**PROPOSED SOCIAL WELFARE FACILITY (RESIDENTIAL CARE HOME FOR THE ELDERLY) IN
“VILLAGE TYPE DEVELOPMENT” ZONE ON APPROVED NAM SANG WAI OUTLINE ZONING
PLAN NO. S/YL-NSW/10 AT LOTS 3670 RP (PART), 3671 RP (PART), 3672 RP (PART) AND 3673
RP (PART) IN D.D.104, NAM SANG WAI, YUEN LONG**

Town Planning Application No. A/YL-NSW/349 - Submission of Further Information (1)

PROPOSED SOCIAL WELFARE FACILITY (RESIDENTIAL CARE HOME FOR THE ELDERLY) IN “VILLAGE TYPE DEVELOPMENT” ZONE ON APPROVED NAM SANG WAI OUTLINE ZONING PLAN NO. S/YL-NSW/10 AT LOTS 3670 RP (PART), 3671 RP (PART), 3672 RP (PART) AND 3673 RP (PART) IN D.D.104, NAM SANG WAI, YUEN LONG
(Planning Application No. A/YL-NSW/349)
Response-to-Comment Table

Drawing No. FIGURE 2.1	Rev. 0
----------------------------------	------------------

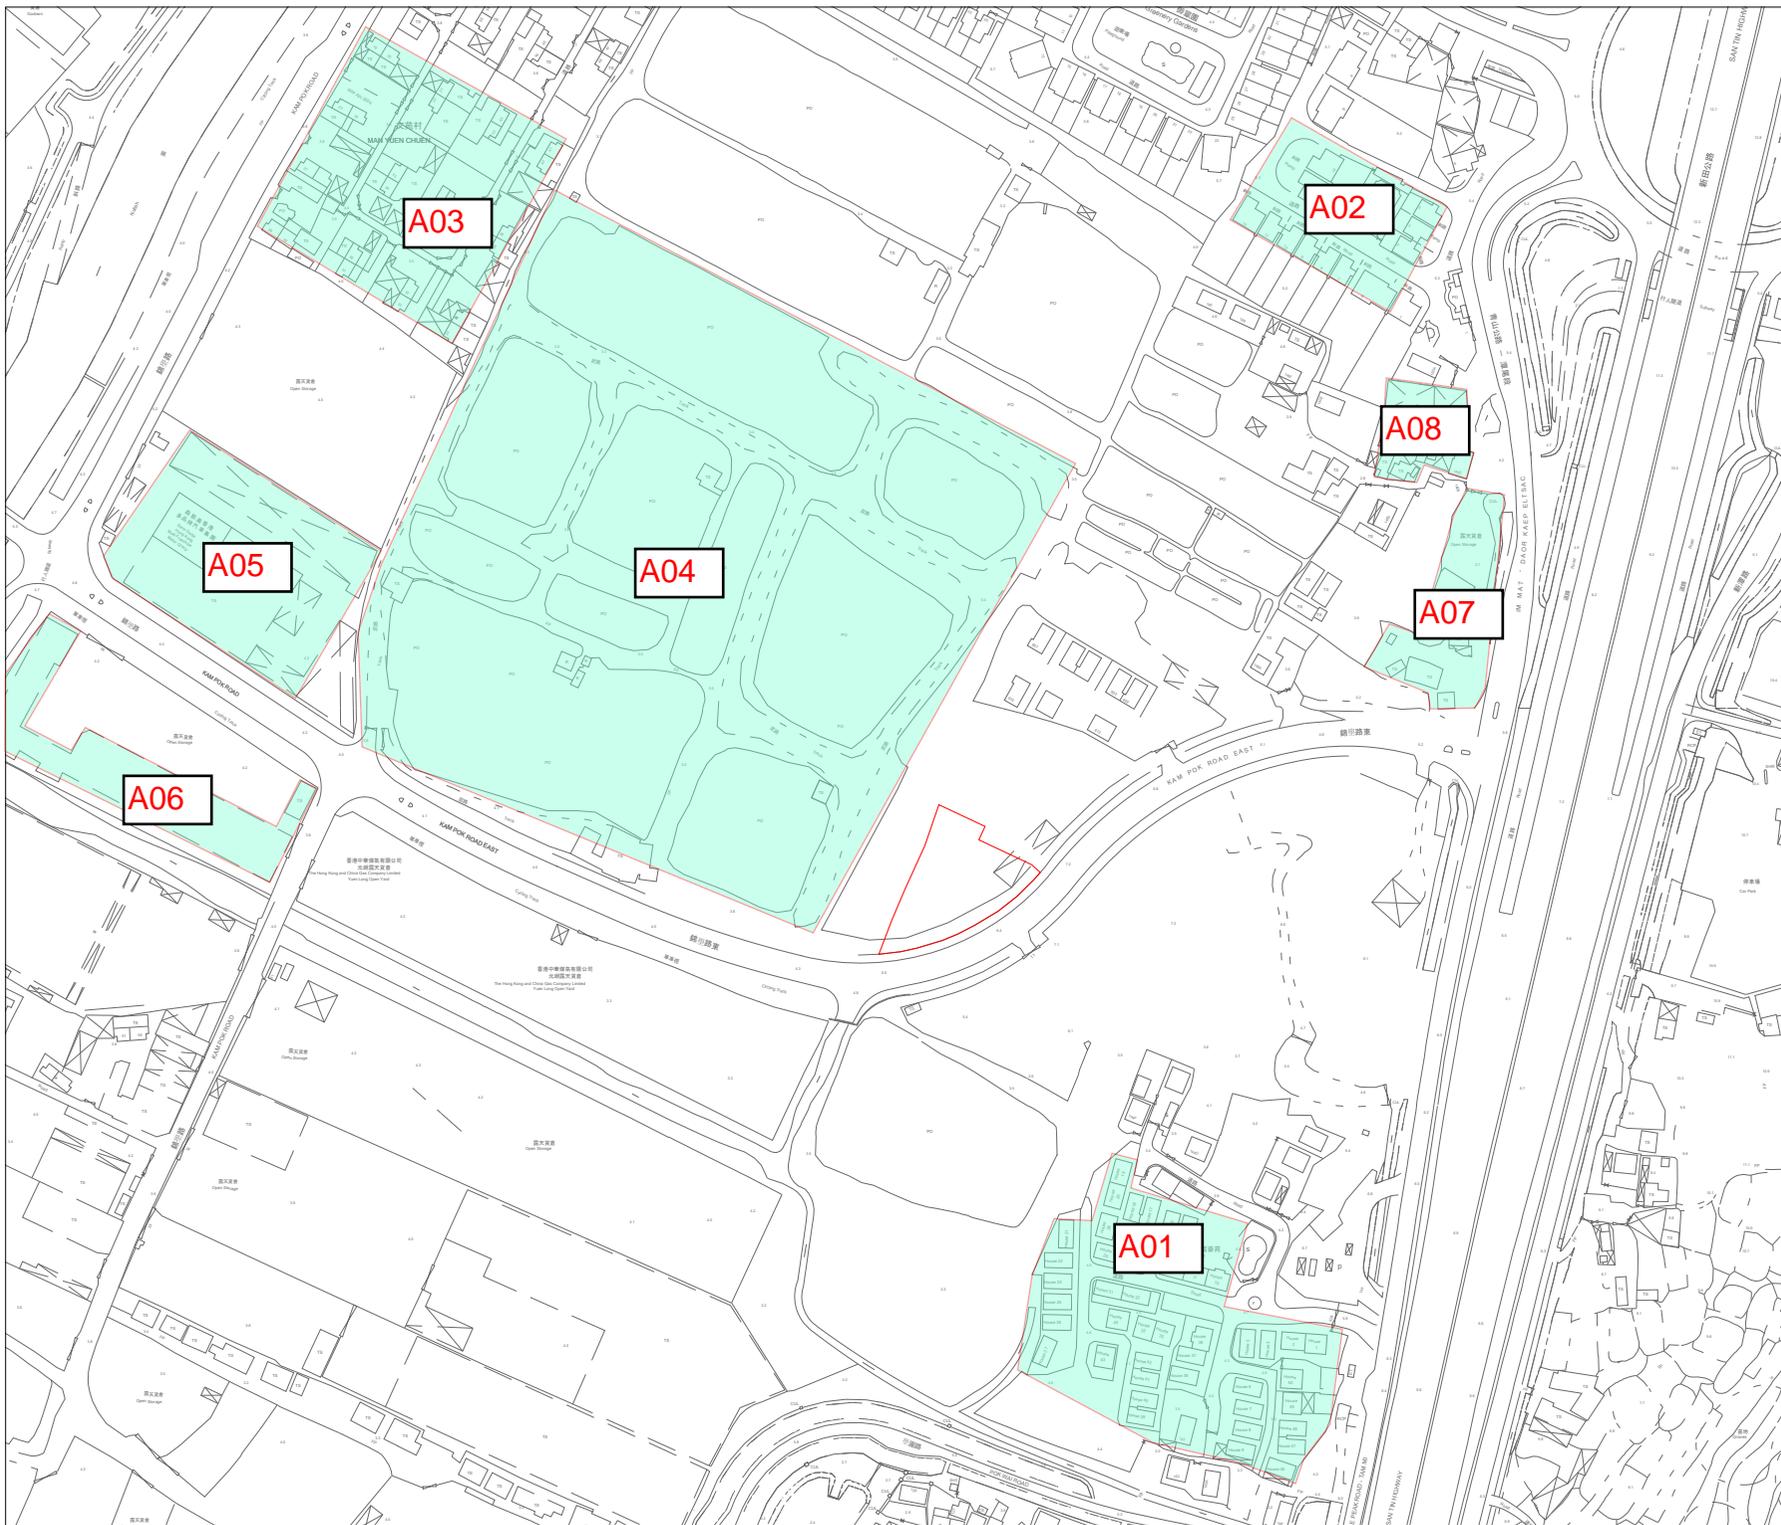
3. Section 2.3.1, Table 2.3 and Figure 2.1 - Please note that not only the domestic premises are the ASRs, some places/premises such as factory and workshop may also be the ASRs. Based on the desktop review, there are some areas in the vicinity of the project site which have been used for workshops/open storage, etc. Please review the potential existing/planned ASRs within the assessment area with reference to the Determination of ASR under the EIAO-TM and update as appropriate.	More ASRs have been identified in Table 2.3 and Figure 2.1. For other areas mainly for open storage use where long duration of exposure to air pollutants is not expected are, therefore, not considered as ASR.

BUFFER DISTANCES

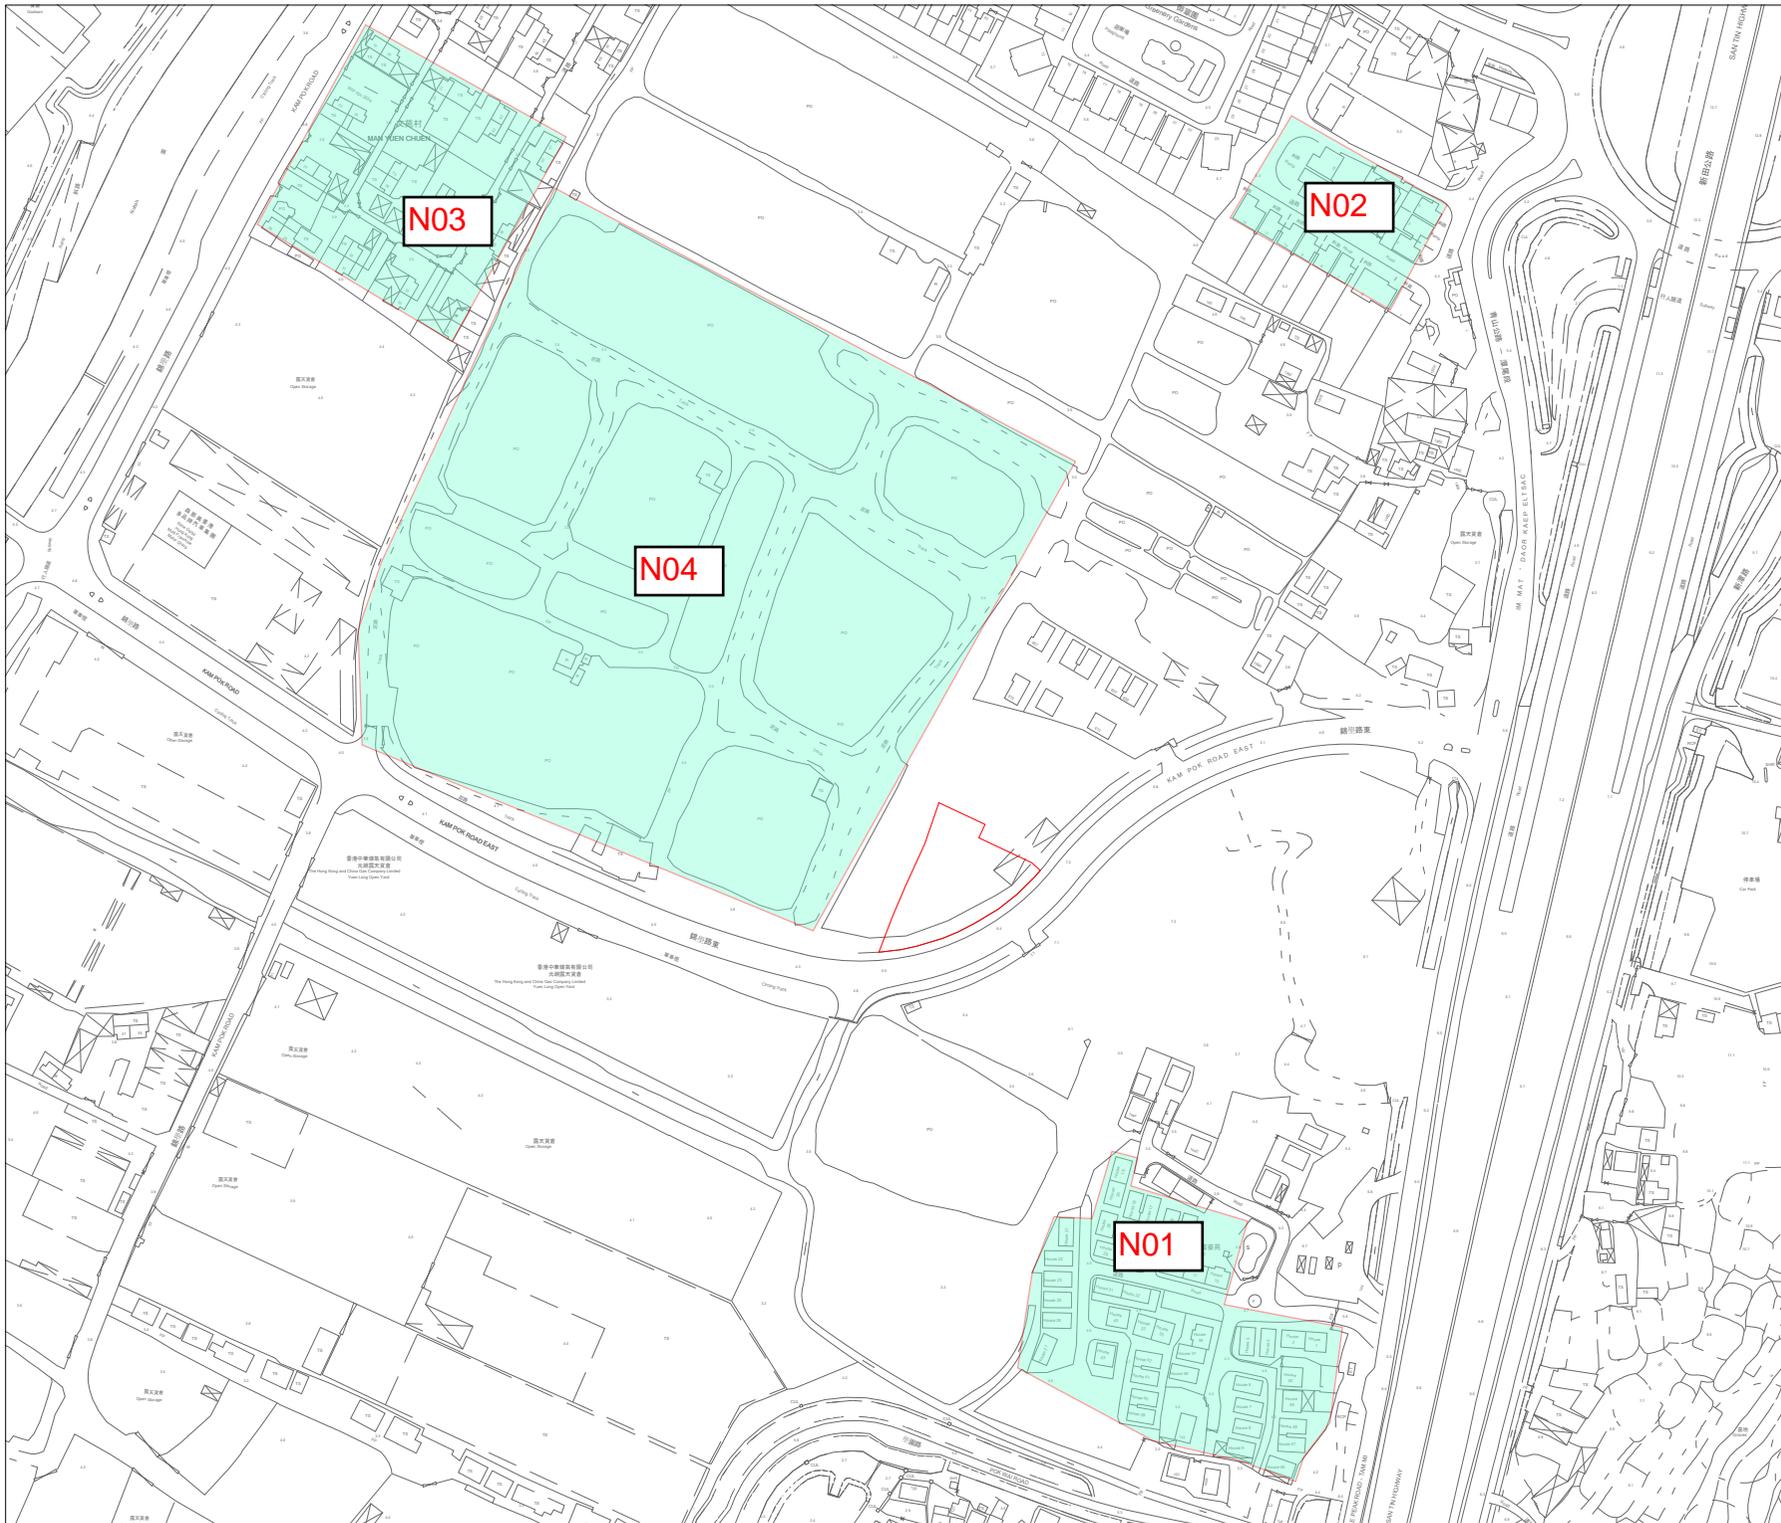
<p>12. Figure 2.2</p> <p>a. The buffer distance should be measured from the edge of road kerb. Please update and present the buffer zone appropriately.</p> <p>b. Please show the road name of Kam Pok Road East clearly in the figure.</p> <p>c. Please add a remark “No air-sensitive use including openable window, fresh air intake and recreational use in open space shall be located within the buffer zone”.</p>	<p>Figure 2.2 is revised accordingly.</p>
<p><u>Sewerage (Please refer to Appendix 2 for the revised SIA)</u></p>	
<p>1. Section 2.2.2 - Please supplement with information of the public sewerage system identified along Kam Pok Road East e.g. alignment, pipe details etc. that is proposed to be utilized for discharging the sewage flow from the application site.</p>	<p>Section 2.2.2 is updated accordingly.</p>
<p>2. Appendix B – The hydraulic assessment should take into consideration the existing and planned developments utilizing the proposed sewerage network. Please revise.</p>	<p>Appendix B is updated accordingly.</p>

Drawing No. FIGURE 3	Rev. 0
-------------------------	-----------

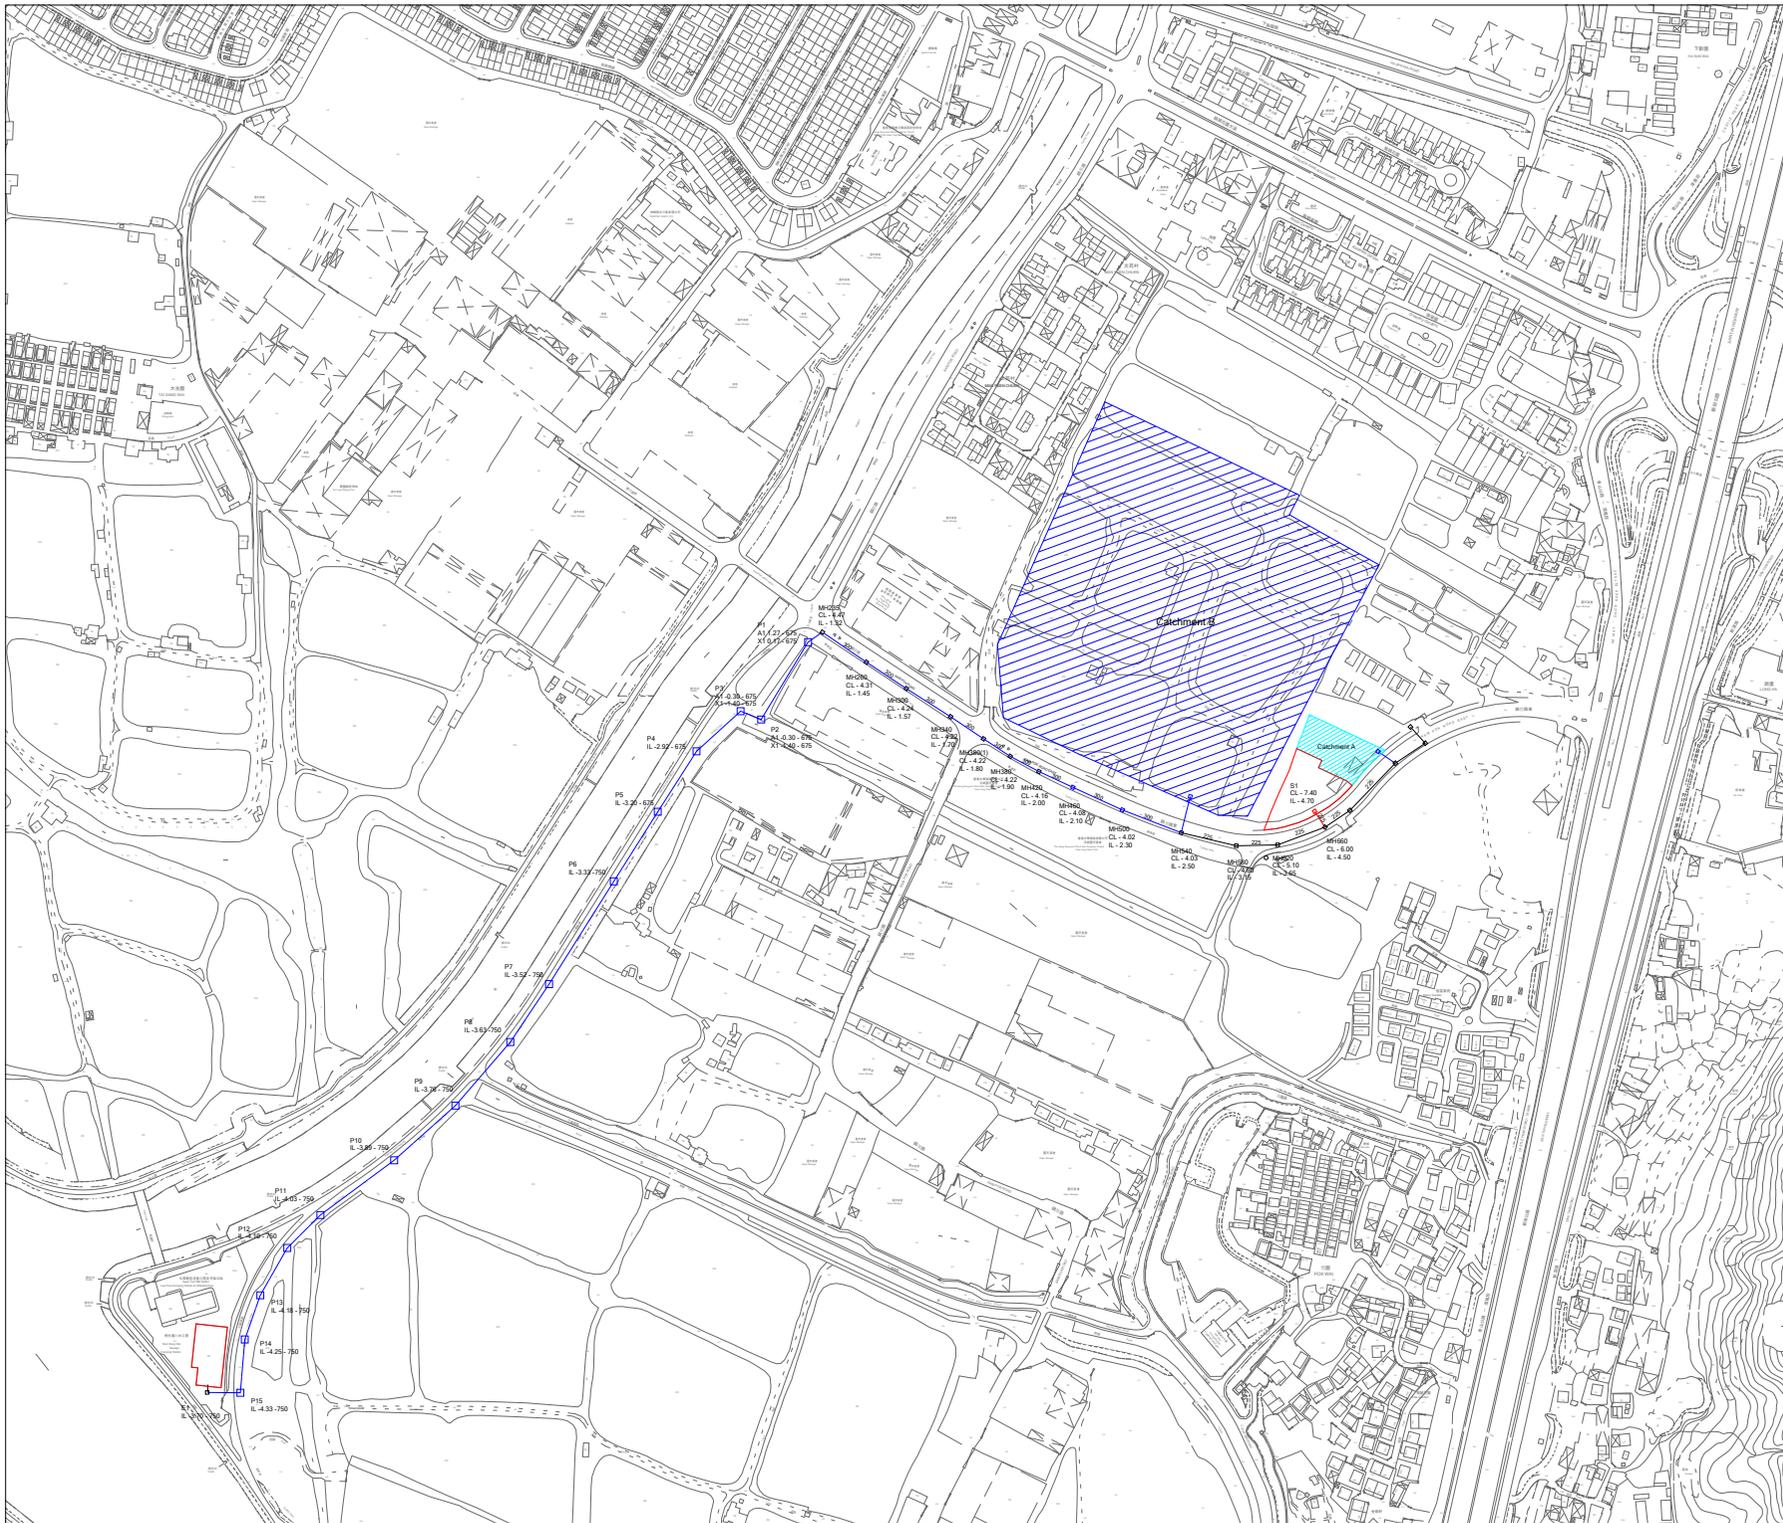
<p>3. Figure 3 – Please indicate the pipes and manholes to be provided under the application and by others.</p>	<p>Figure 3 is updated accordingly.</p>
<p>4. Please provide the population intake year.</p>	<p>The population intake year is provided in Section 1.3.1.</p>
<p><u>Email dated 4th July 2025 refers:</u></p>	
<p><u>Drainage Services Department (Please refer to Appendix 2 for the revised SIA)</u></p>	
<p>1. Para. 2.2.1 - Please check if the Figure 2 including existing sewerage record;</p>	<p>Figure 2 is supplemented.</p>
<p>2. Para. 2.2.2 - Please review "coube";</p>	<p>The typo is revised.</p>
<p>3. Para. 2.2.2 - Please review "termination" should read "terminal";</p>	<p>The typo is revised.</p>
<p>4. Para. 3.1.2 - Please clearly show the existing sewerage system on drawings for reference;</p>	<p>The existing sewerage system is indicated in Figure 3.</p>
<p>5. Please advise who will implement and maintain the proposed sewerage system/facilities. Please discuss in the report text and prepare a drawing for comment; and</p>	<p>Figure 3 is updated to include liability of implementation and maintenance. Detailed discussion refer to Para 2.2.2 and 2.2.3.</p>

<p>6. Figure 3 - Please indicate all cover levels. Please note that the cover level(s) of terminal manhole(s) should be higher than that of the downstream public manhole(s). Please include the above in report text and drawing remark.</p>	<p>The cover levels has included in Figure 3. Report text is provided in Para.2.2.3.</p>
<p><u>Email dated 27th June 2025 refers:</u></p>	
<p><u>Architectural Services Department (Please refer to Appendix 3 for the photomontages)</u></p>	
<p>Please provide photomontages of the proposal in its surrounding context from different vantage points.</p>	<p>The proposal in its surrounding context could be seen from 2 different vantage points as demonstrated by the photomontages attached in Appendix 3.</p>
<p><u>Email dated 27th June 2025 refers:</u></p>	
<p><u>Social Welfare Department</u></p>	
<p>Based on the submitted Schedule of Accommodation (SoA), Plans and Drawings, Supplementary Planning Statement, etc., please find the comments below for follow-up:</p>
